RE: METRO WEST STATION EIS – SSI 22765520 - NORTH STRATHFIELD STATION

Submission for the Metro West Station EIS – North Strathfield Station

Response to EIS and Station Design Principles

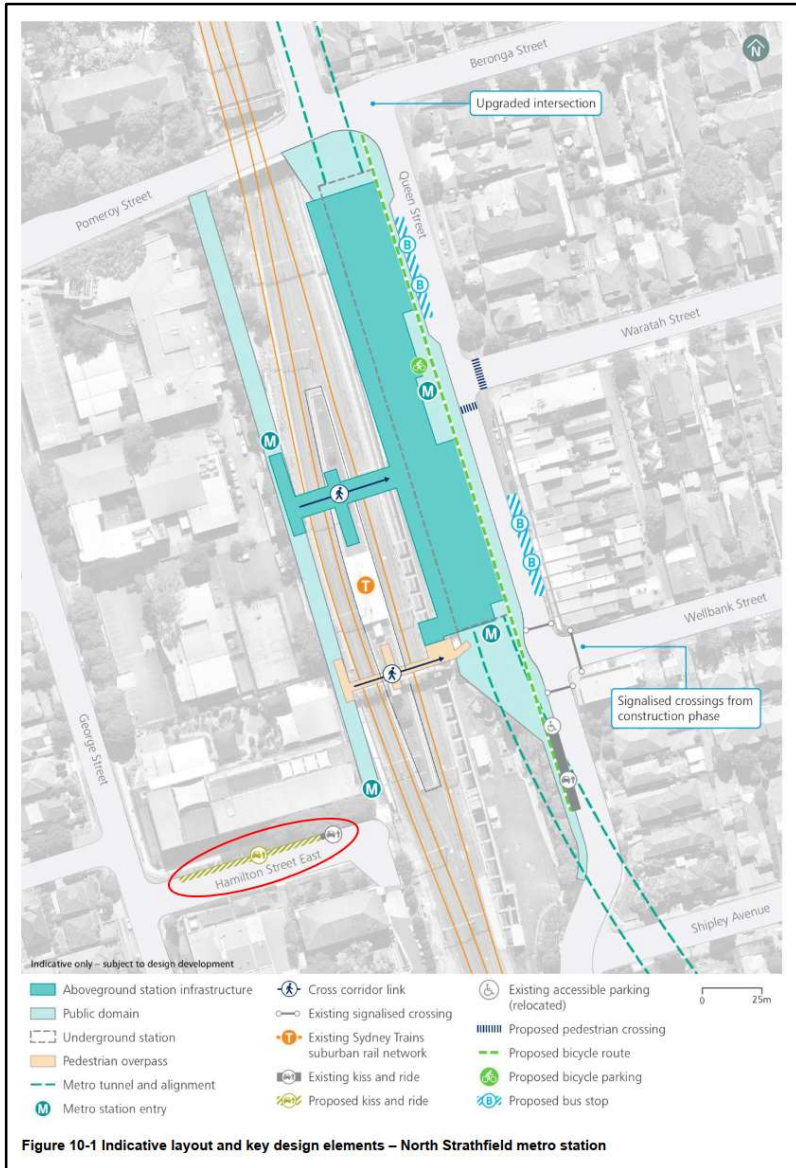
The customers have a bias towards the west, yet access is not well provided. The higher density residential is located on the west, the education facilities are on the west and the entertainment, retail and dining is located at the Bakehouse Quarter which is on the west. The corridor directly west of the heavy rail line is also where Canada Bay Council is proposing that all of the future higher density residential growth will occur.

Interchange via an overhead pedestrian bridge provides a poor customer experience and the requirement for vertical travel at both ends will likely lead to bottlenecks during peak times. The Social Impacts report forming part of the EIS also raises the prospect that the proposed North Strathfield Metro Station will be a significant interchange location for transport users wanting to access Sydney Olympic Park for large events. The proposed overhead bridges with the requirement for vertical movement at both ends are likely to result in significant bottlenecks for patrons. The EIS does not adequately assess this issue or analyse the safety risks associated with crowd crush during these peak event times.

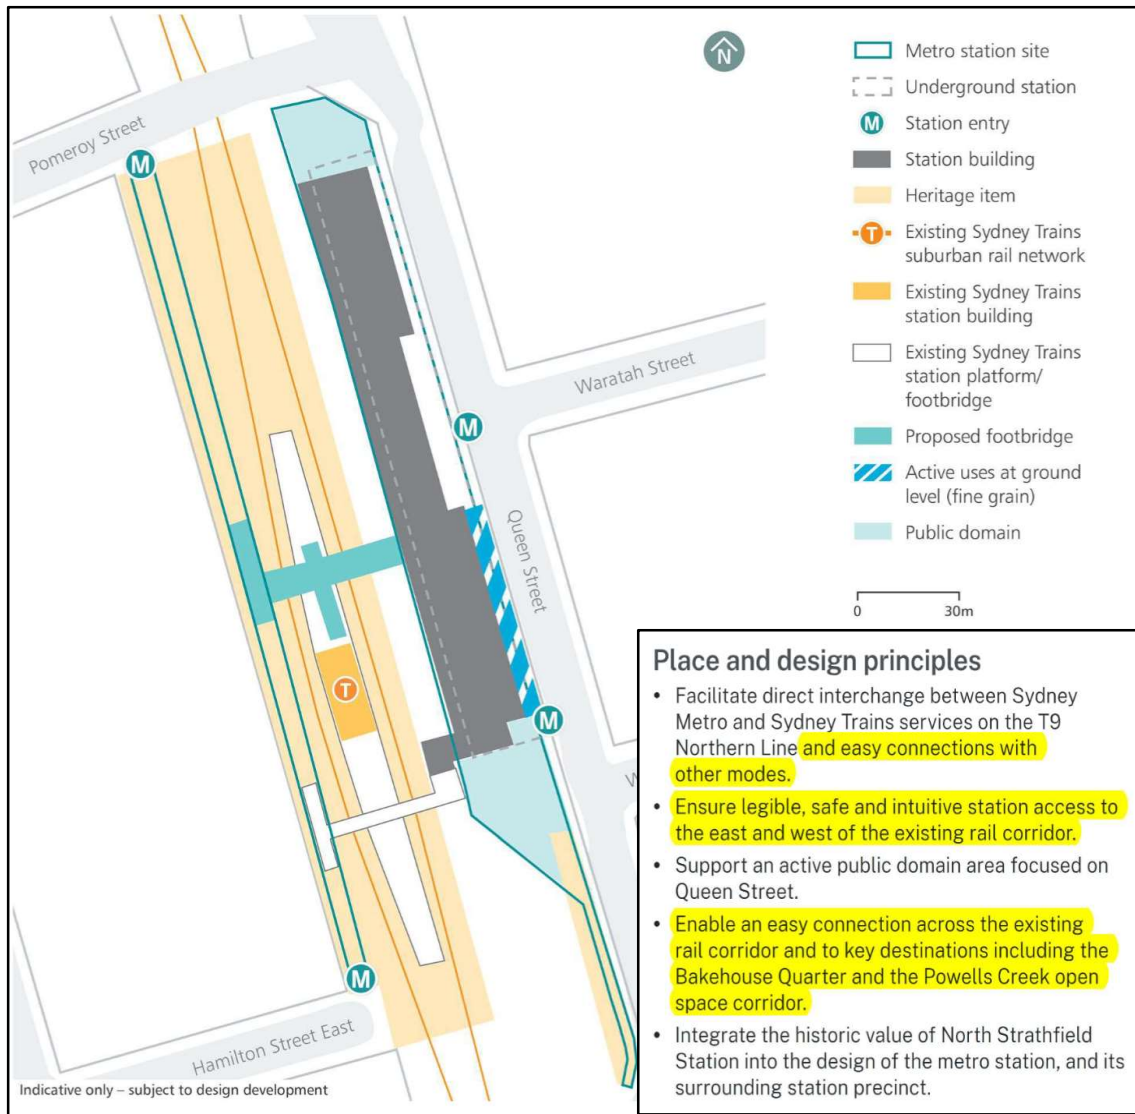
The clear focus for this railway station and a significant role is that it will be one of the most important interchange points between metro in Sydney trains and further that it

is expected to functional as a relief for crowds attending events at Sydney Olympic Park.

These are the obvious priorities understandably for this type of railway station. However, this should not mean that its attention and contribution to the notion of placemaking will or would receive significantly subordinate and minor consideration in the context of the opportunities. Instead these opportunities can and should be deliberately curated and presented as part of a major investment towards the significant station upgrade programme.

By modern standards the current precincts immediate vicinity and existing railway station is dated in terms of access arrangements, pedestrian permeability, amenity and safety. It is questionable as to whether an appropriate effort has been made to allow the proposed facility to provide greater servicing capacity to those using the station as their local facility, compared to maximizing benefits in the design for those moving through the station facility as an interchange. By not considering this, it becomes more of an issue, thereby creating more challenges to the amenity and placemaking of North Strathfield.

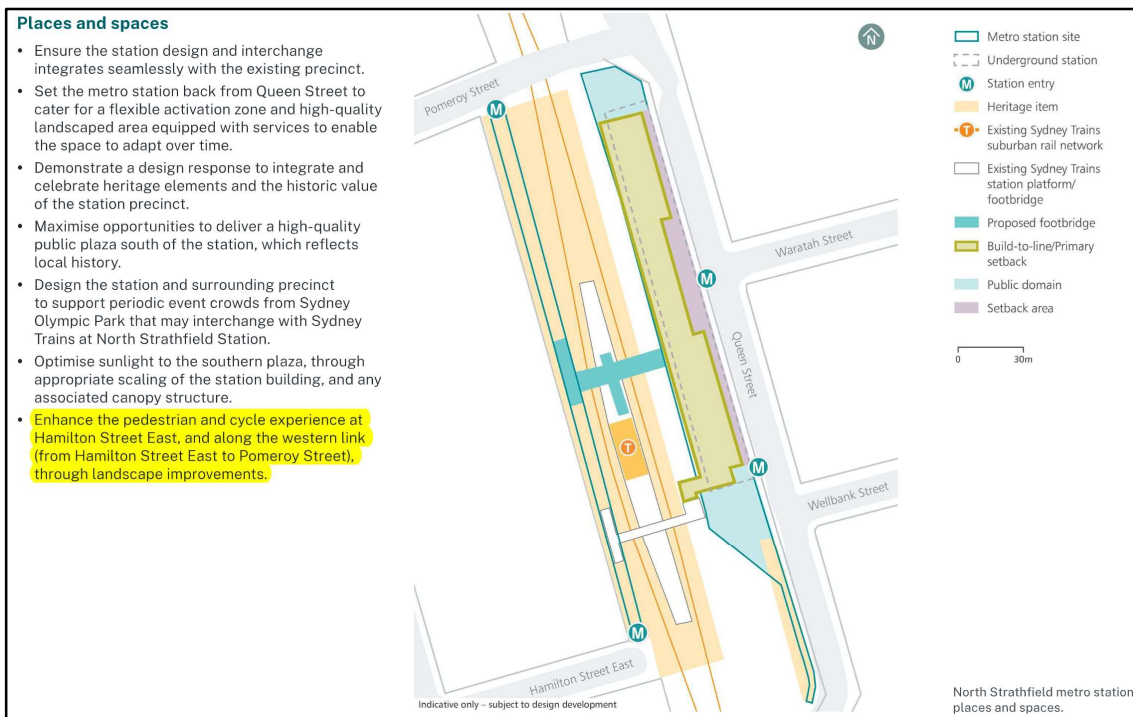
The commentary around this strategy on the east of the station is in contrast and in turn serves to highlight the second-rate solutions which have been provided and considered appropriate to the west connected by railway bridges and long gun barrel footpaths with long walking distances to points of interest and facilities.
